Final Plat - Comment Response Letter

Citizen on Constitution  
El Paso County, Colorado

Prepared: October 26th, 2022

PCD File Number: SF-226

AKERS DR & ACCESS ROAD ROUNDABOUT  
 EL PASO COUNTY, COLORADO  
 ROADWAY CONSTRUCTION DOCUMENTS  
**TYPICAL SECTIONS**

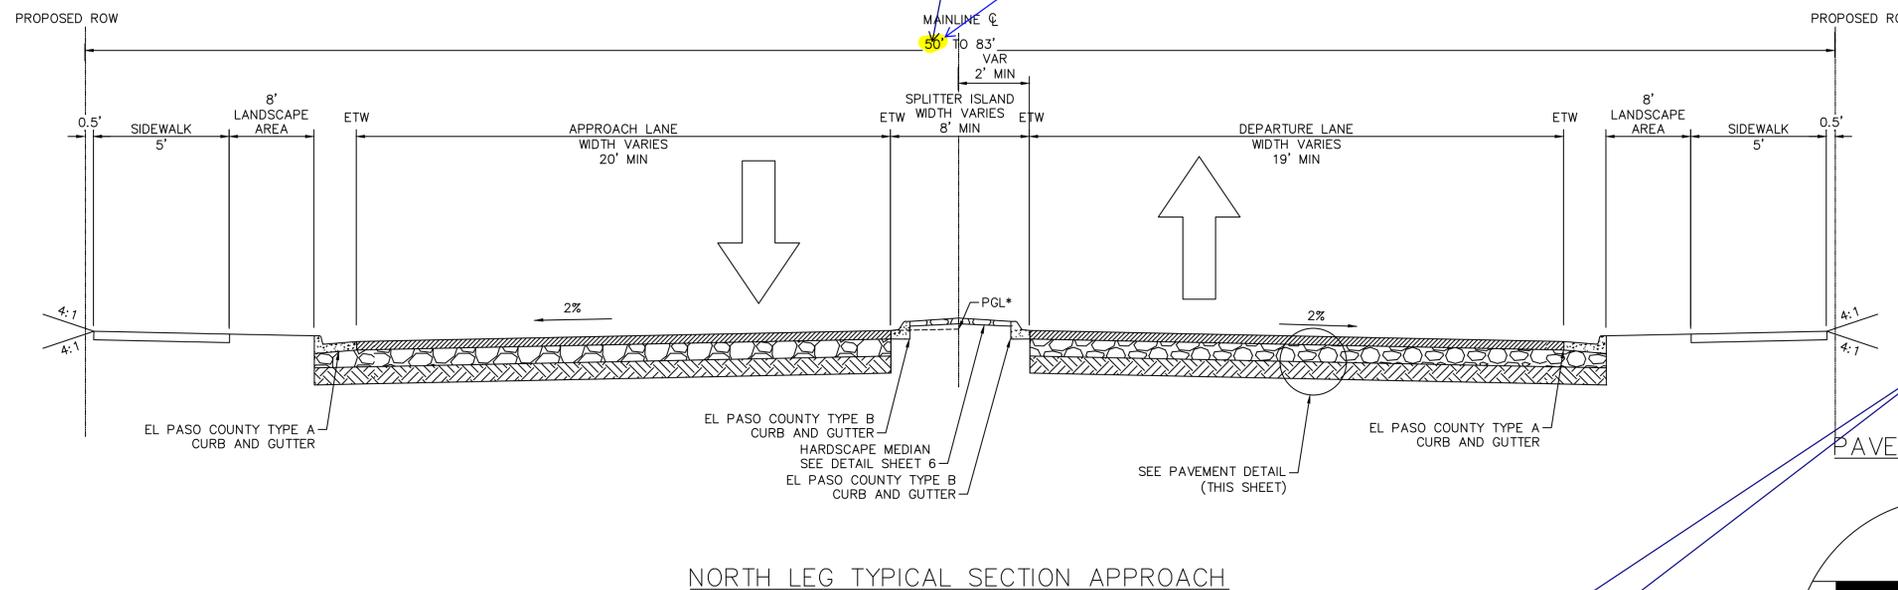
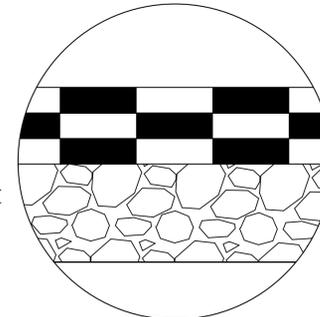
Please identify that these values are for bid purposes only and that a pavement report shall be submitted to the County for review and approval.

**PAVEMENT DETAIL UPDATED.**

AKERS DR & ACCESS ROAD ROUNDABOUT  
 EL PASO COUNTY, COLORADO  
 ROADWAY CONSTRUCTION DOCUMENTS  
 ROADWAY DETAILS

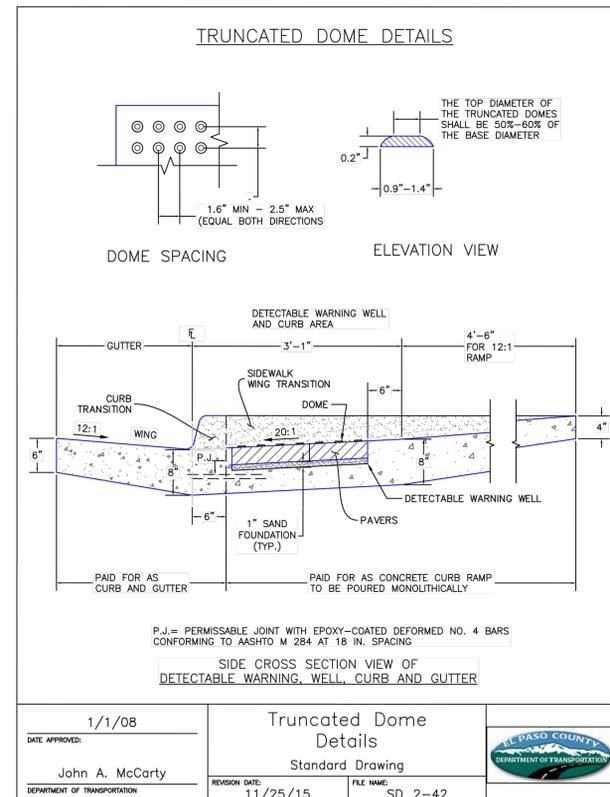
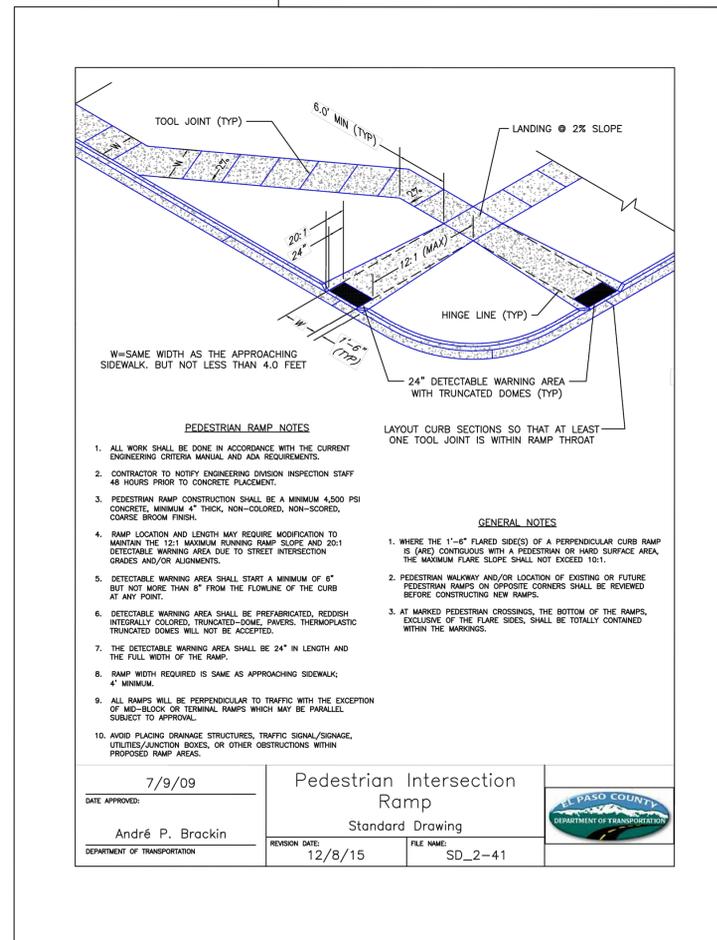
Review 3 comment:  
 Update to the latest standard County details

Review 4 Unresolved. The latest County details can be found in the following link:  
[https://library.municode.com/co/el\\_paso\\_county/codes/eng\\_ineering\\_criteria\\_manual\\_?nodeId=ENCRMA\\_APFSTDR](https://library.municode.com/co/el_paso_county/codes/eng_ineering_criteria_manual_?nodeId=ENCRMA_APFSTDR)

**DETAILS UPDATED PER LINK**

AKERS DR & ACCESS ROAD ROUNDABOUT  
EL PASO COUNTY, COLORADO  
ROADWAY CONSTRUCTION DOCUMENTS  
ROADWAY PLAN

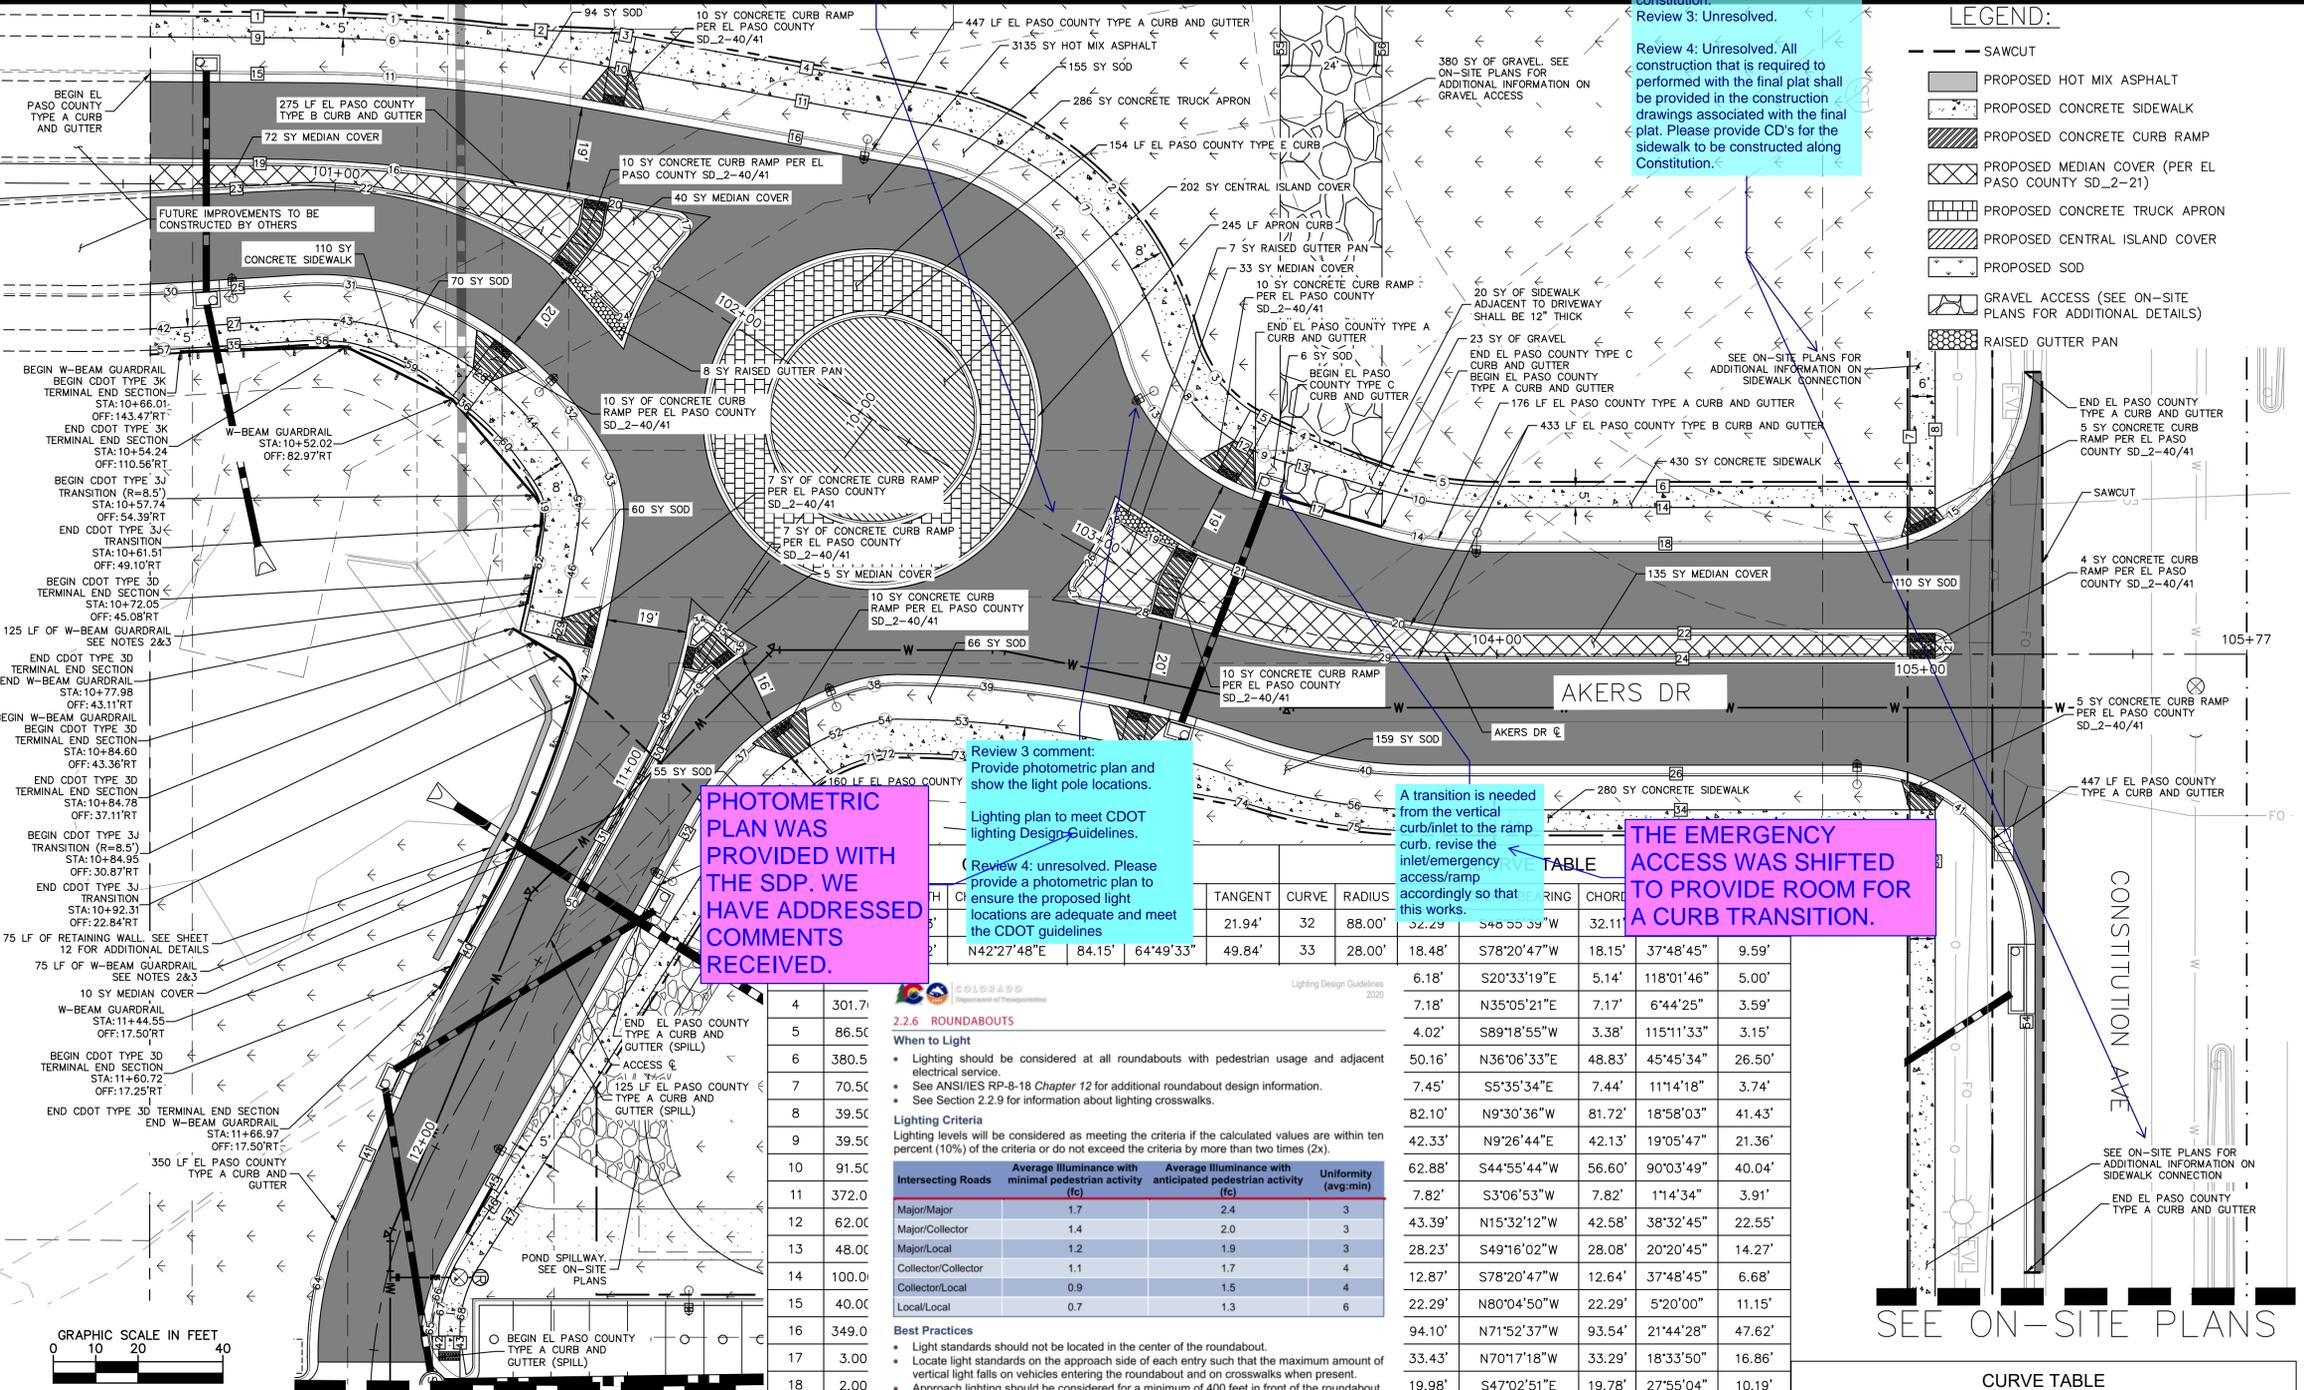
Review 3 comment: provide lane widths at entry and exit of roundabout and at travel lane around the roundabout.  
Review 4: Please provide the width of the travel lane at the roundabout

Review 2 comment: Please extend construction drawings to where the sidewalk will tie into the adjacent properties sidewalk along constitution.  
Review 3: Unresolved.  
Review 4: Unresolved. All construction that is required to be performed with the final plat shall be provided in the construction drawings associated with the final plat. Please provide CD's for the sidewalk to be constructed along Constitution.

Review 3 comment: Provide photometric plan and show the light pole locations.  
Lighting plan to meet CDOT lighting Design Guidelines.  
Review 4: unresolved. Please provide a photometric plan to ensure the proposed light locations are adequate and meet the CDOT guidelines

A transition is needed from the vertical curb/inlet to the ramp curb. revise the inlet/emergency access/ramp accordingly so that this works.

**SHEET ADDED ROADWAY PLAN 2 (11) TO COVER SIDEWALK EXTENSIONS TO THE WEST AND EAST. LINE TABLES UPDATED ACCORDINGLY.**

**DIMENSION ADDED TO THRU LANES**

**PHOTOMETRIC PLAN WAS PROVIDED WITH THE SDP. WE HAVE ADDRESSED COMMENTS RECEIVED.**

**THE EMERGENCY ACCESS WAS SHIFTED TO PROVIDE ROOM FOR A CURB TRANSITION.**

K:\DEN\_Civil\096481004 - El Paso Constitution\CADD\PlanSheets\RAB\Signing and Striping.dwg Loeffler, Tyler 9/9/2022 12:23 PM

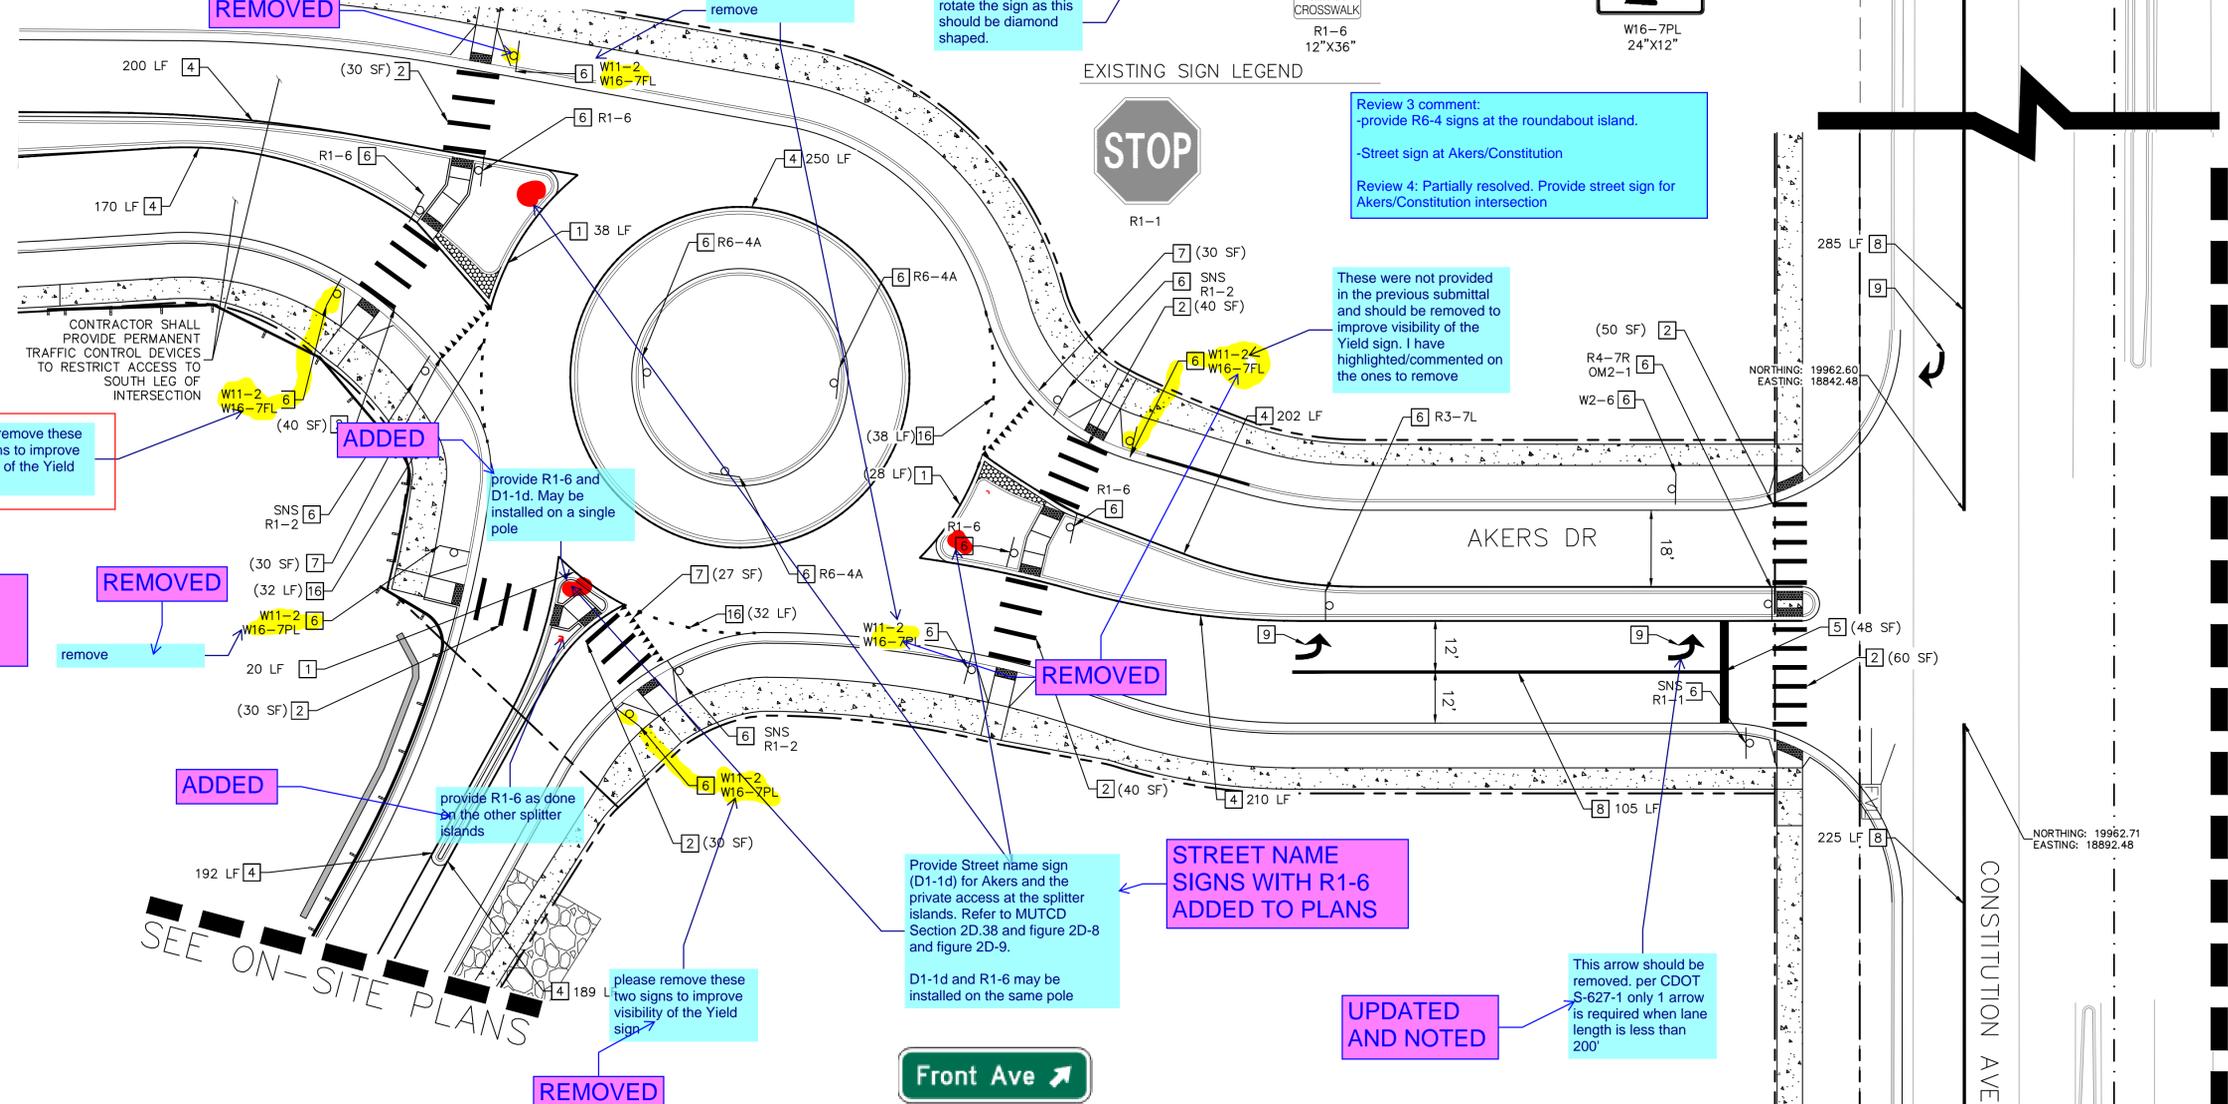
please remove these two signs to improve visibility of the Yield sign

W11-2 AND W16-7PL REMOVED.

NORTH LEG TYPICAL SECTION APPROACH

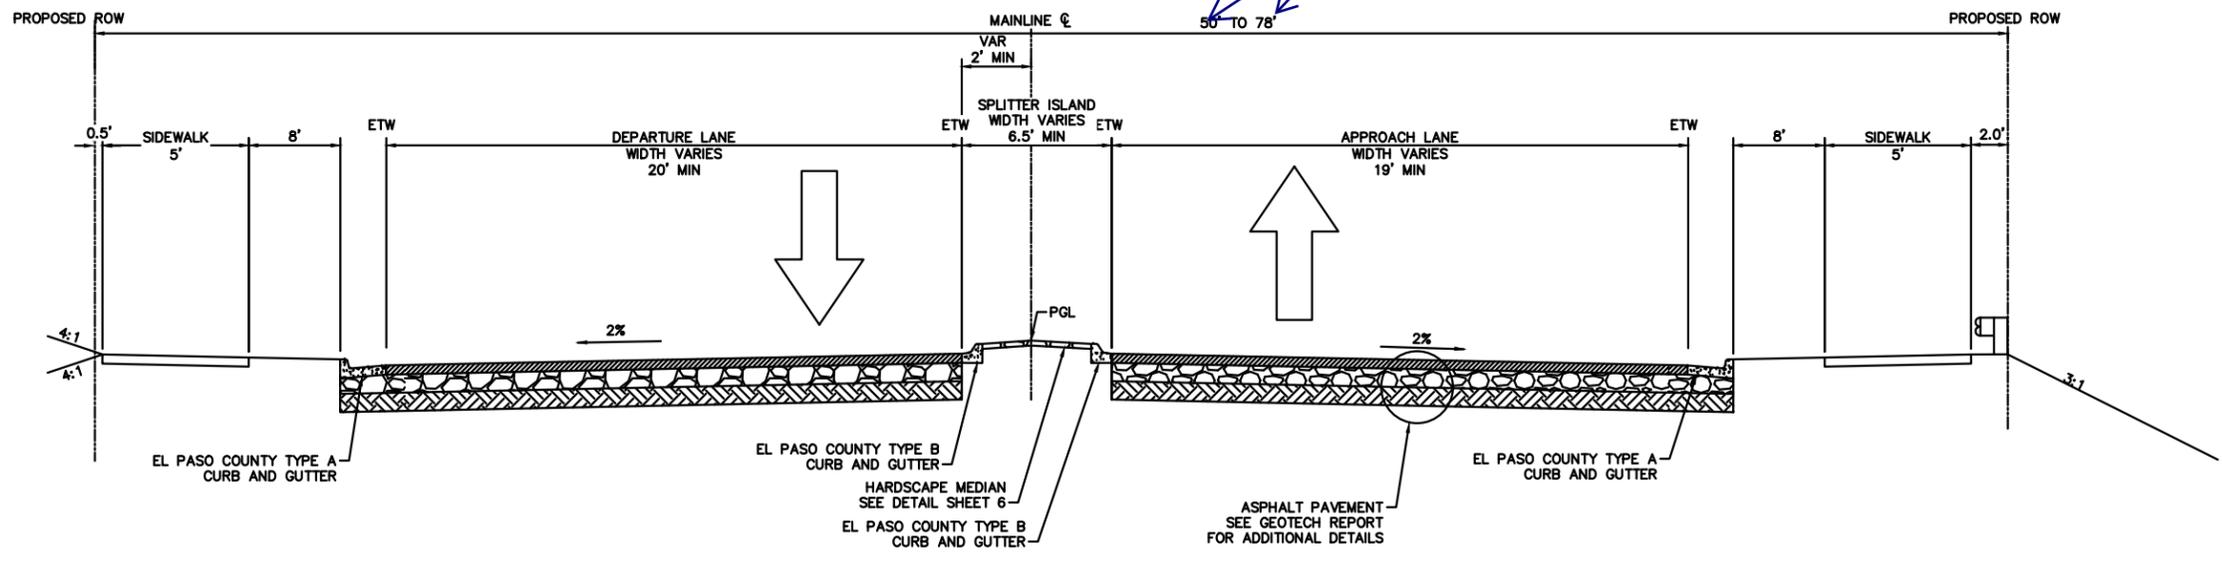
ROW width shall be 80' min. per the roadway classification. Revise

ROW WIDTHS UPDATED ACCORDINGLY

SOUTH LEG TYPICAL SECTION APPROACH

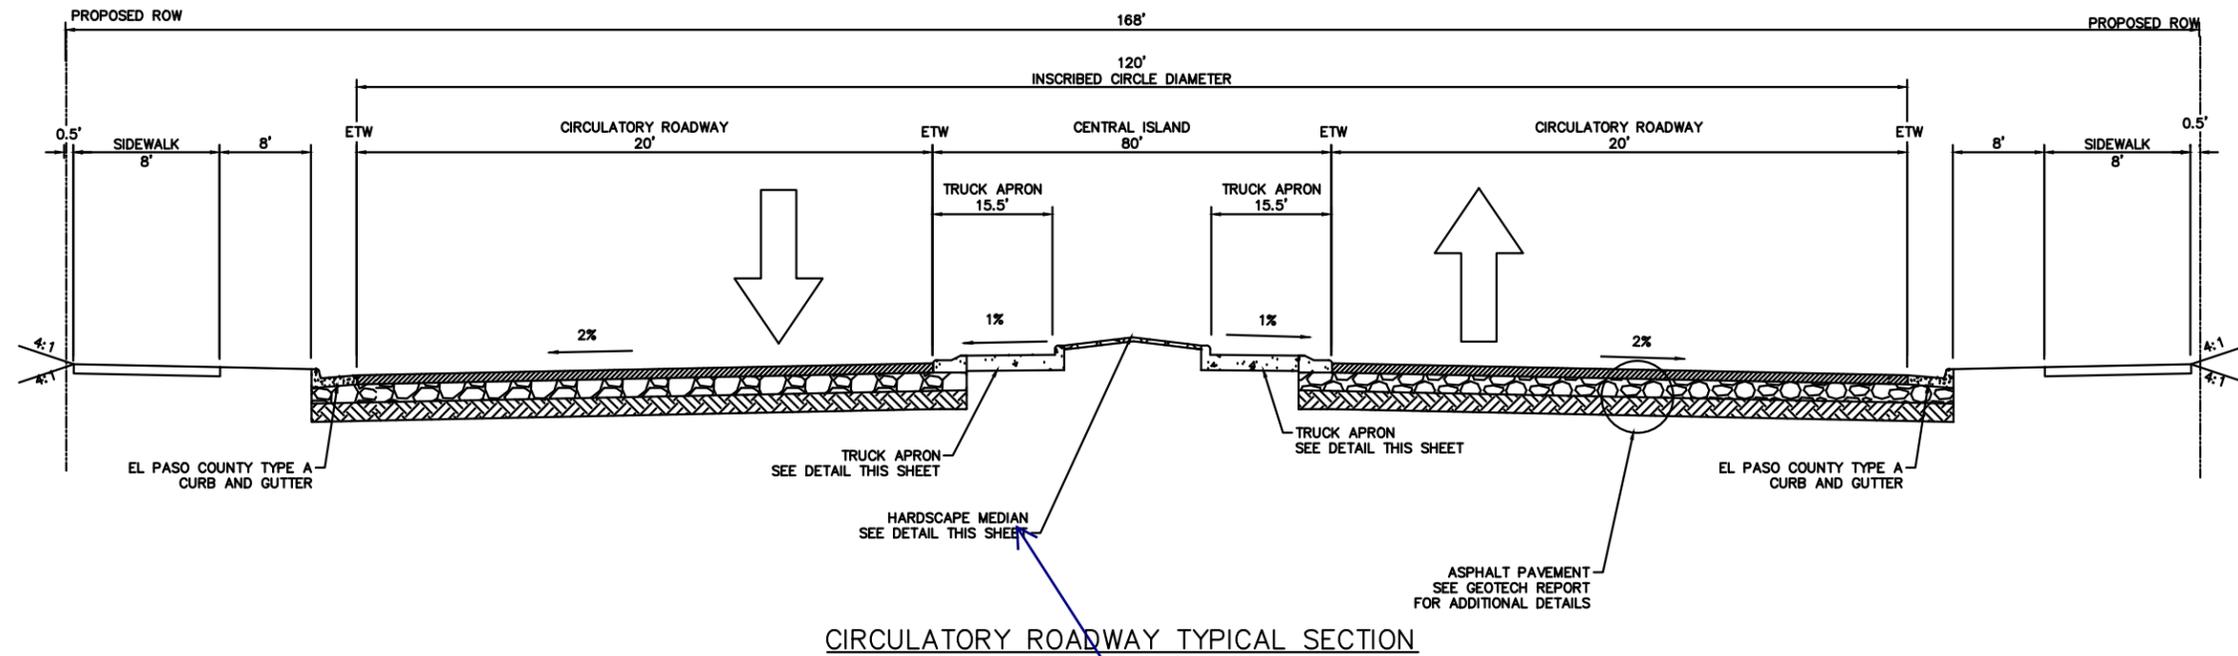
see comment on CDs

UPDATED ACCORDINGLY
